18 February 2021

Selwyn District Council
Attention: Jocelyn Lewes

PRIVATE PLAN CHANGE REQUEST TO THE OPERATIVE SELWYN DISTRICT PLAN- RFI PC200069: SPRINGS ROAD LINCOLN

Figure 1: NZLRI LUC Classes 1-3 (Land Resource Inventory) (Source: Canterbury Maps)

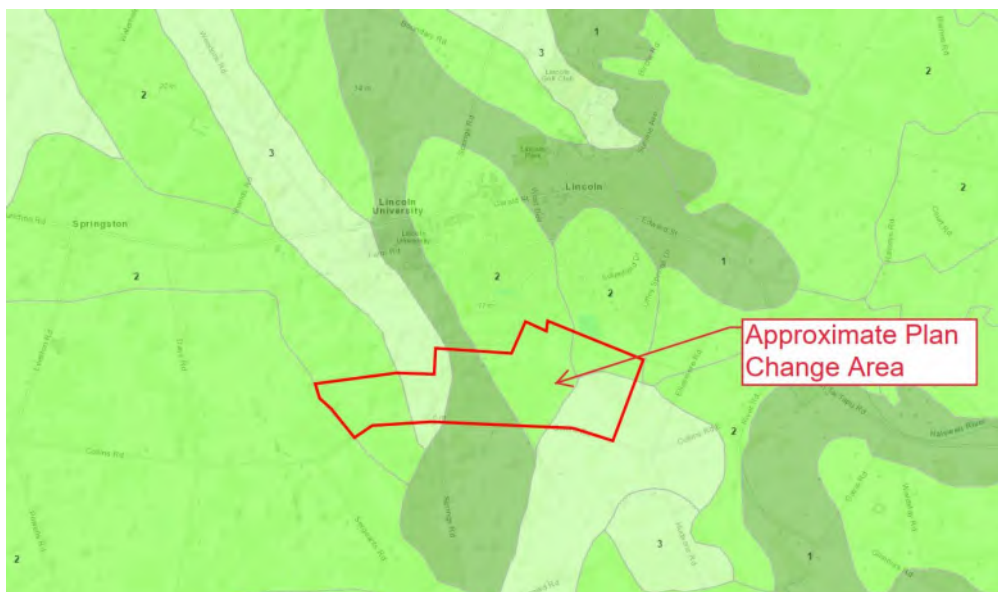
RFI 19. The area of the plan change request contains Class 1, 2 and 4 soils. Policy B1.1.8 seeks to avoid rezoning land which contains versatile soils for new residential or business development if the land is appropriate for other activities; and there are other areas adjoining the township which are appropriate for new residential or business development which do not contain versatile soils. Please address this policy and provide an assessment against both tests contained within it.

40. The area of the plan change request is comprised of Land Use Capability (LUC) Class 1, 2 and 3 soils as illustrated below in **Figure 1**.
41. **Figure 1** also illustrates the LUC soil 'versatility' classifications for the Lincoln Township surrounds. Notably, many existing Outline Development Plan areas (i.e. Flemington, Barton Fields, Rosemerryn, Te Whariki and Liffey Springs) occupy soils characterised as Classes 1 and 2. As the request area is predominantly comprised of Class 2 and 3 soils, it

is considered a more efficient use of land when compared to these other recently developed, or developing areas (occupying Class 1 and 2 soils).

LANDUSE AND DENSITY MAP (nts)

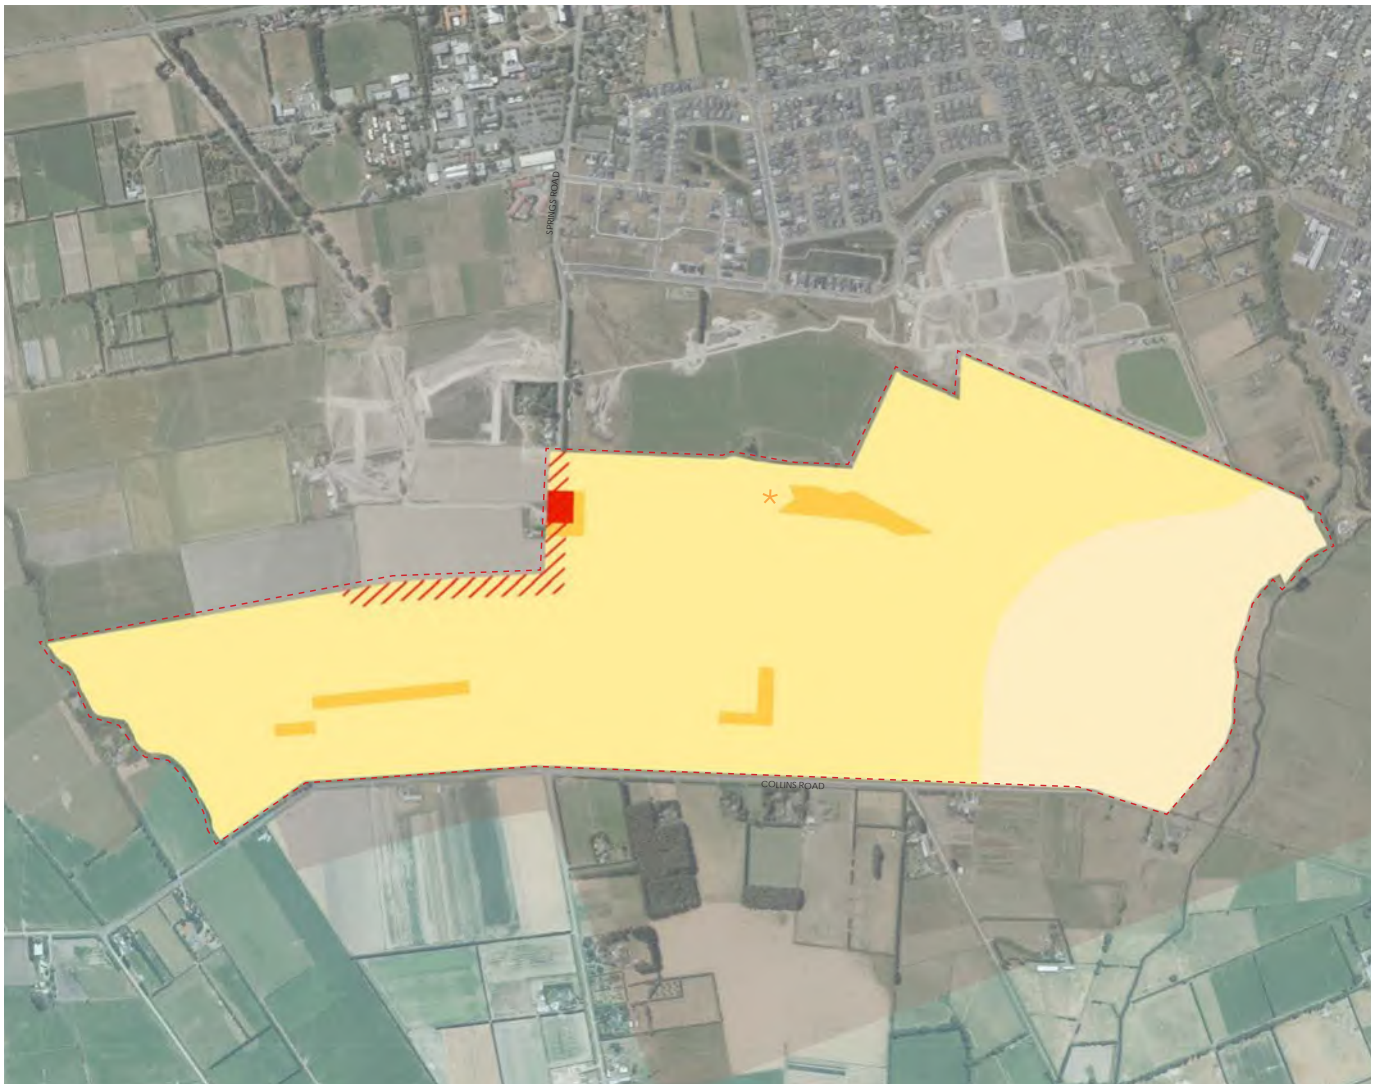
RFI 11. Please identify the size of the area to be zoned Living X around Chudleigh. Please consider and advise if there is an alternative way within the plan change request to acknowledge Chudleigh rather than spot zoning. Please also identify if any rules are required to ensure that the context and setting of Chudleigh are not compromised by the surrounding development as proposed e.g. setback and fencing provisions, restriction on further subdivision.

14. The zoning around the Chudleigh heritage setting has been amended to Living Z on the amended ODP and commentary is provided in the ODP text. It is noted that the extent of the setting is the immediate garden setting of the house (as marked on the Proposed District Plan maps), rather than the land parcel as a whole, notwithstanding the potential archaeological values of the property.

Figure A1: Peak flood depths in a 0.2% AEP flood event including the effects of climate change (2081-2100, RCP8.5)
Model results provided by Selwyn District Council.

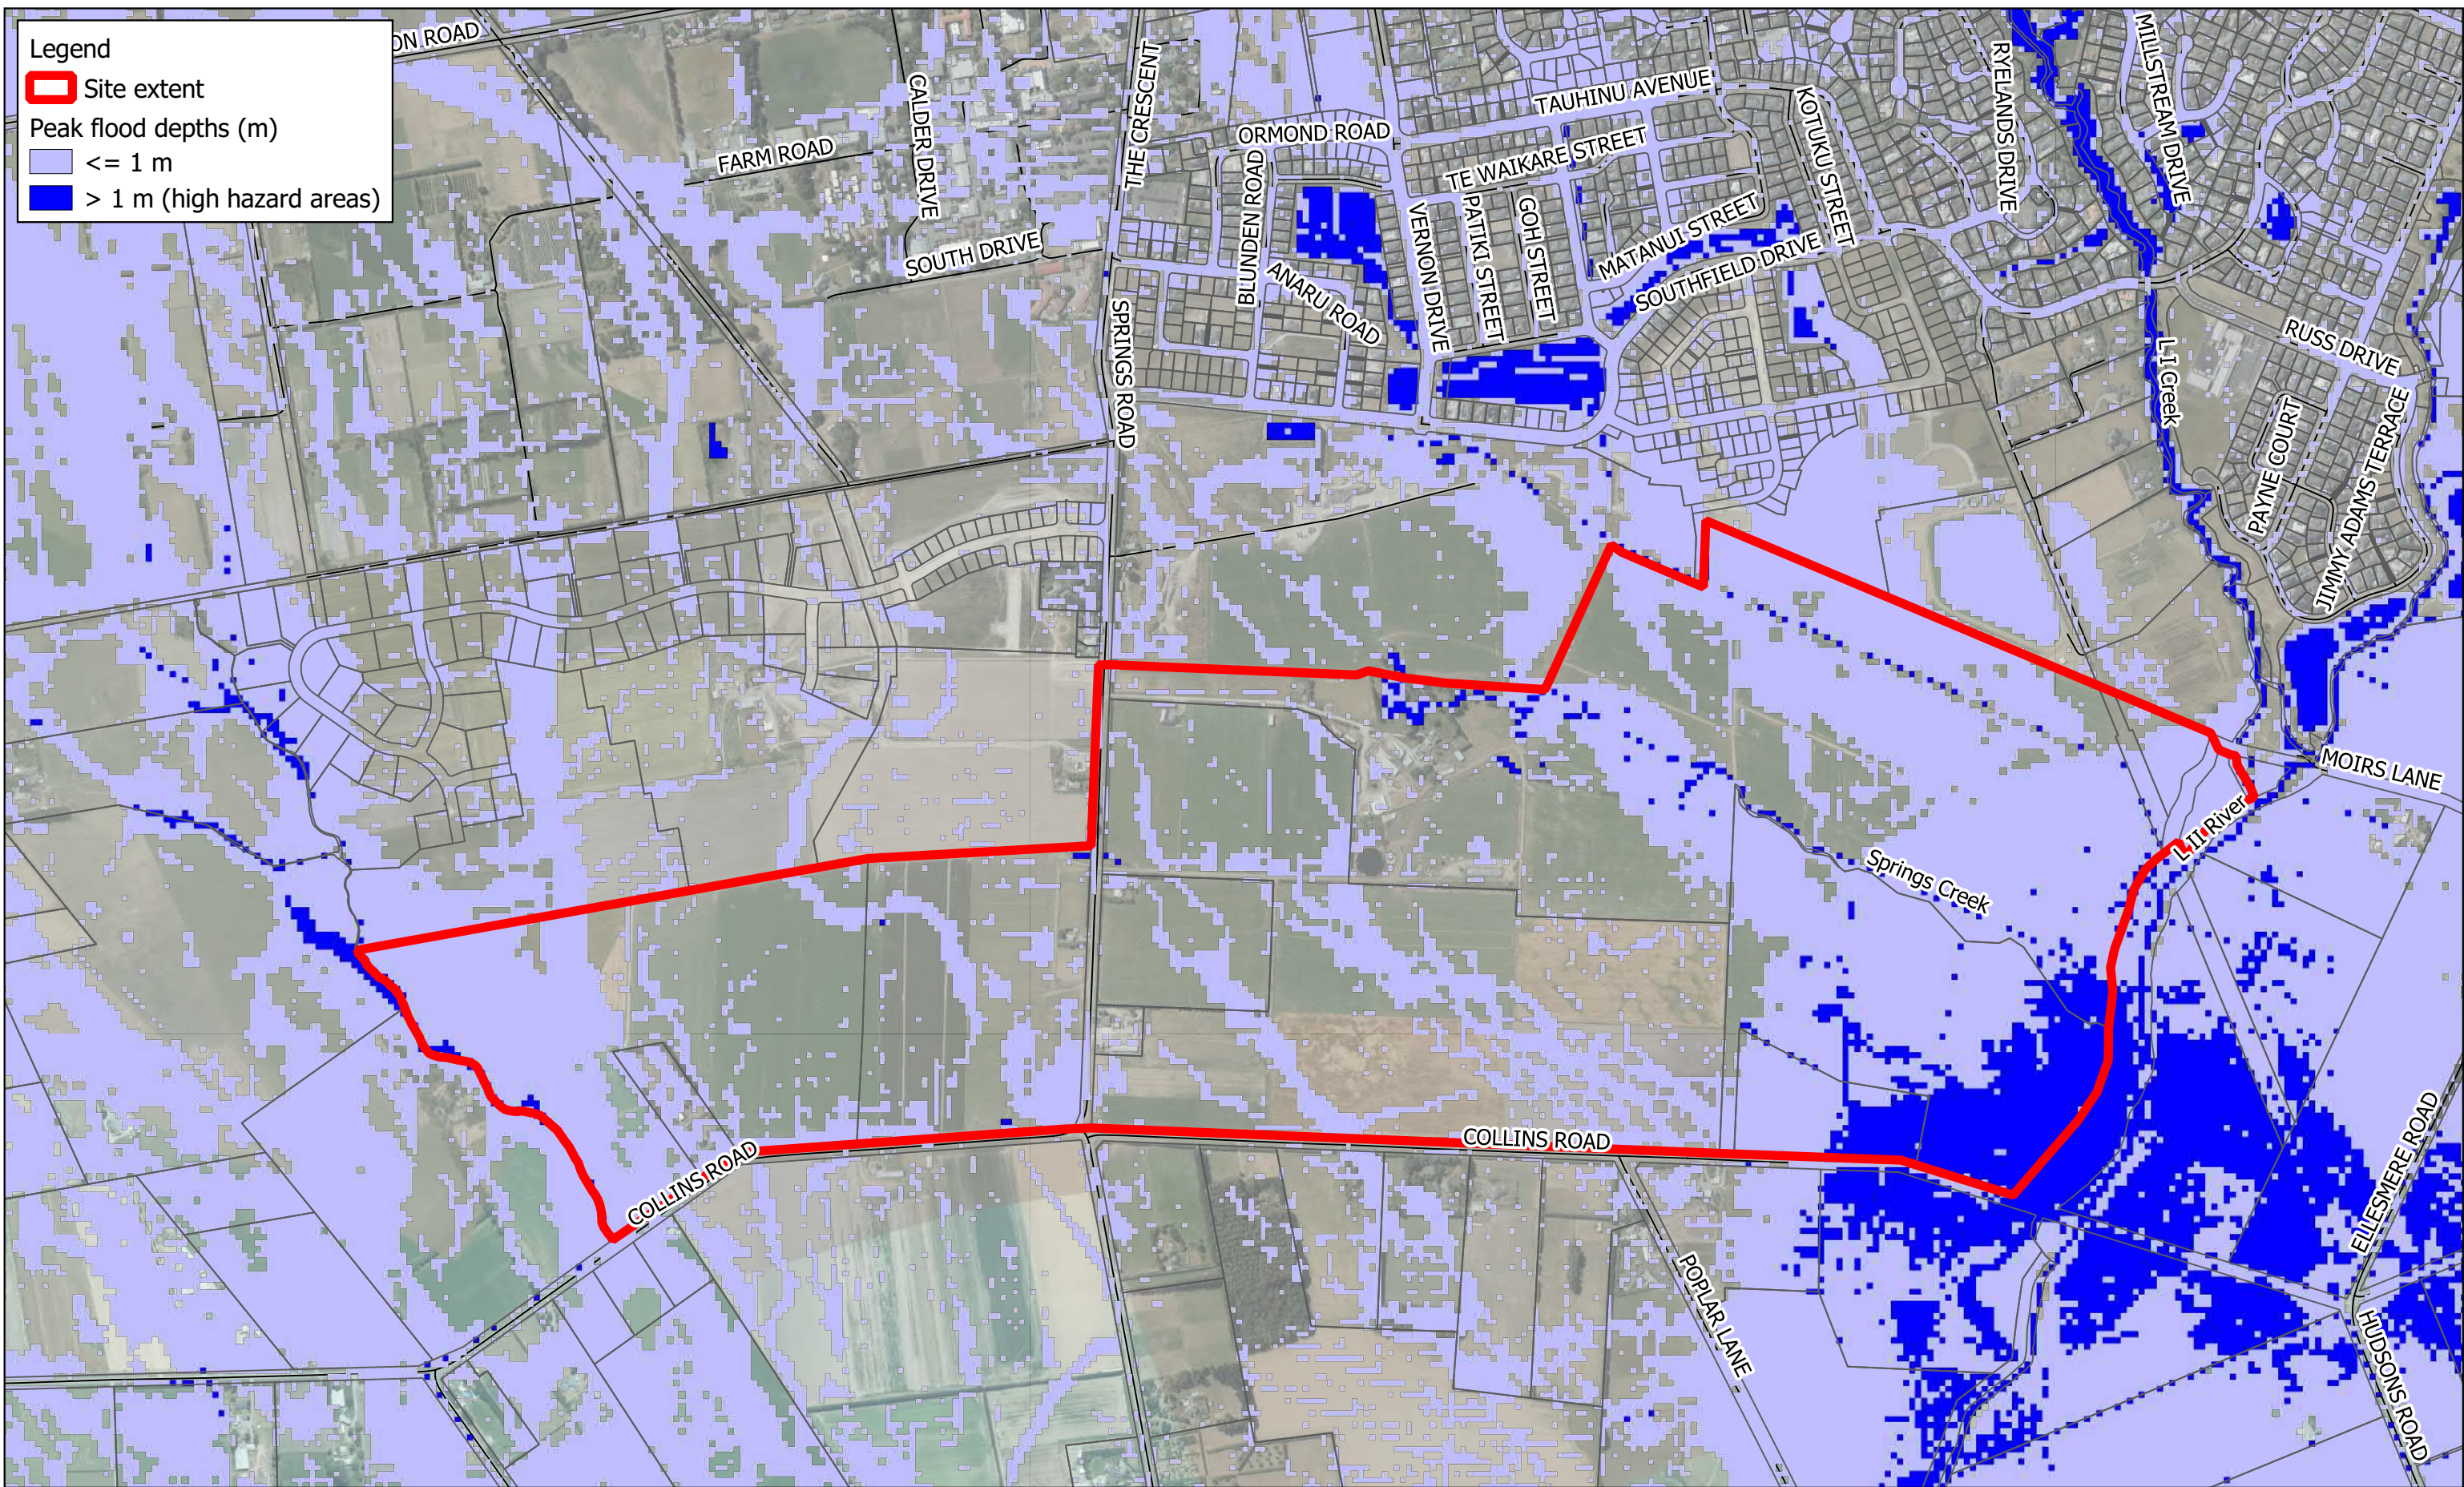
RFI 8. *As acknowledged in the plan change request, the area is subject to inundation in a 200-year Average Recurrence Interval flood event, and that it may contain areas that fall within the Regional Policy Statement definition of 'high hazard'. Please ensure that the assessment requested above considers CRPS Policy 11.3.2 Avoid development in an area subject to inundation.*

11. Please refer to memo prepared by E2 Environmental in response to RFI query No. 8. The response provides further explanation around definition of high hazard, and notes that no proposed residential zoned areas are in the "high hazard zone" where velocity × depth factor is modelled to be greater than 1 m²/s or flood depths are greater than 1 meter in a 0.2% AEP flood event. Furthermore, also refer to the original Inovo services report as part of the plan change application Appendix A, section 2.5 and table 3 and Figure A1 which addressed flooding as well.

As per CRPS 11.3.1, development in high hazard areas will be avoided. In some minor locations, the high hazard areas identified by the model results will need to be verified against finished levels due to the hydraulic model's coarse representation of the terrain.

CRPS 11.3.2 relates to areas outside of the high hazard area but that are subject to inundation in the 0.5% AEP flood event. In these areas, development will also be avoided where there is increased risk to life. In the subdivision design phase, this would also consider access / egress routes in addition to maintaining appropriate freeboard above the 0.5% AEP flood event for building floor levels. Where suitable, there may be filling of ground levels to above the 0.5% AEP flood level to provide platforms for development. However, this would be dependent upon the ability to provide compensatory storage and ensure there are no negative effects downstream of the site. Existing areas of inundation may also be shifted through the development of stormwater / flood management infrastructure. The effects of climate change will be included in any assessment / design.
